Addendum 2

Water control structure demolition and replacement

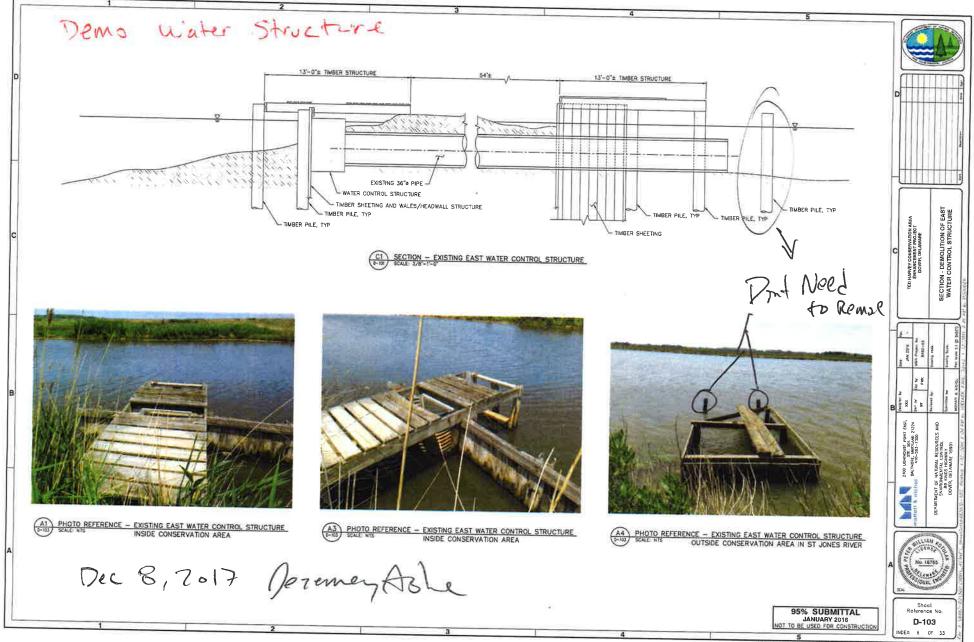
The contractor will be responsible for demolition and the legal disposal of the entire east water control structure located on C-106. The contractor is encouraged to examine the water control structure prior to biding. A reference section of existing conditions can be found on sheet Reference No. D-103 of this addendum. Based on the contractors discretion, timber portions of the structure may be extracted or broken (provided they don't interfere with the new structure).Timber structures are to be removed on both sides (impoundment and St. Jones) of the levee. Far reaching timber piles within the St Jones may be left.

Upon completion of the demolition, the contractor will be responsible for replacing the water control structure with an in-kind structure. The contractor will work with the owner to install the in-kind structure according to the sketch that is provided within this addendum dated Dec 8, 2017.

- The riser to be installed is a polyriser <u>http://www.polyriserandpipe.com/</u>
- The flap gate to be installed is a tide flex gate (series TF-2) <u>http://www.polyriserandpipe.com/</u>
- The pipe is to be a min 50 foot long 24" HDPE solid wall SDR 32.5.
- Rip rap to be installed will be R-6 (approx. 30 Tons) on the St. Jones side of the levee
- The timber walkway is to be installed to the top of the riser and gradually tie into the dike. The timber piles are to be 8"X8" minimum.
- All hardware is to be HDG or stainless steel.
